Attachment 4 25-Foot Radius of Influence for Line Drives

Attachment 4 Figure 4-1 NRC Modeled Potentiometric Drawdown for Line Drive in Zone 1

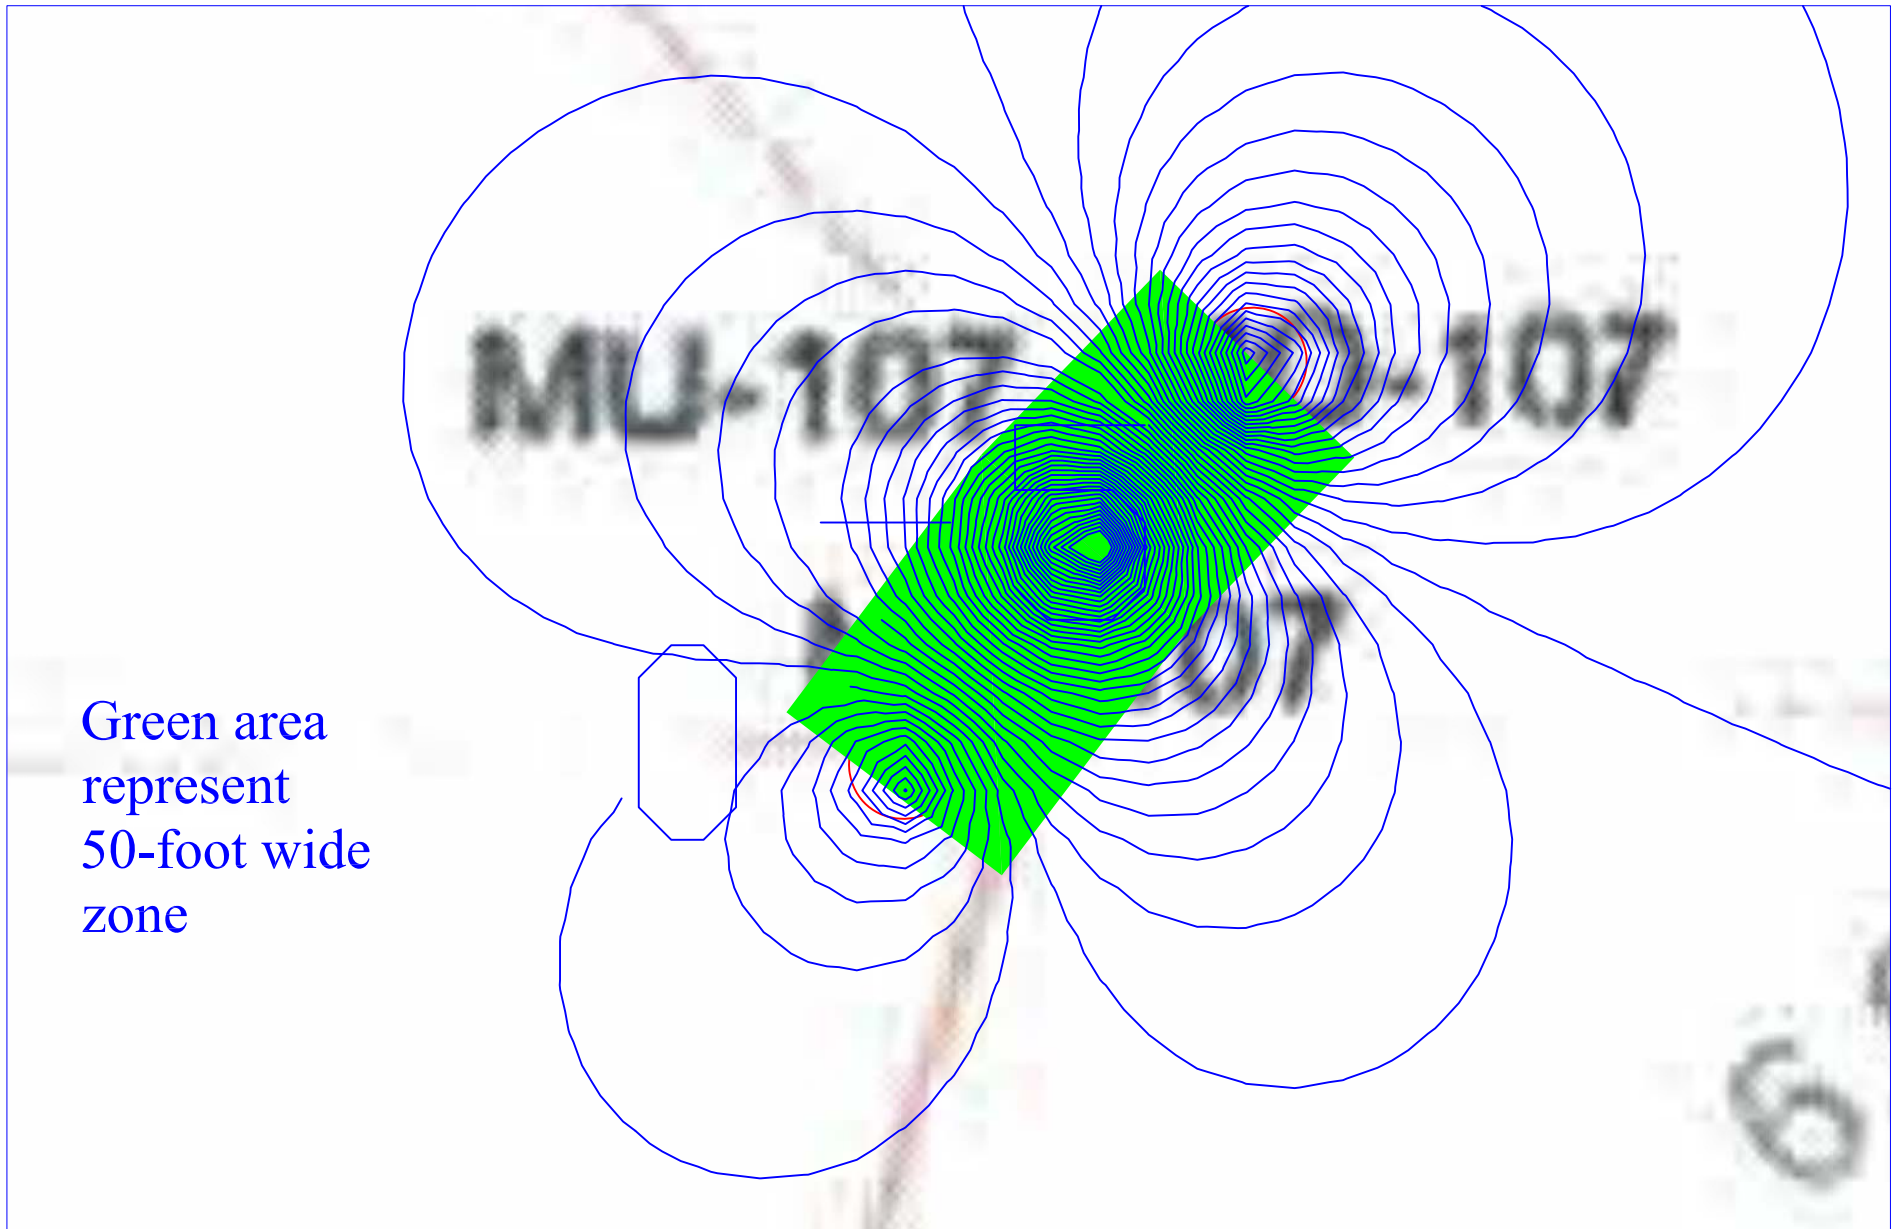
Lost Creek has proposed isolated line drives and suggest that the area of influence for financial surety is a 25-foot radius around each well and each well separated by 50 feet. Lost Creek has not provided justification for the 25-foot radius of influence or any other operational constraints on line drives.

Staff constructed a simple AEM model to verify the area of influence of a line drive (for the model input, see Appendix 4-1). Unfortunately, because of the lack of data to constrain the operations, staff cannot fully evaluate the line drives. However, a contour map of model-predicted surface in Zone 1 is shown on Attachment \$ Figure 4-1 for a line drive which consists of two injection wells and a single extraction well operating at flows one-half those proposed by Lost Creek for a 5-spot pattern. The contours at these low flow rates suggest that the area of influence would exceed 25 feet.

Consequently, Staff cannot verify the 25-foot radius of influence for line drives.
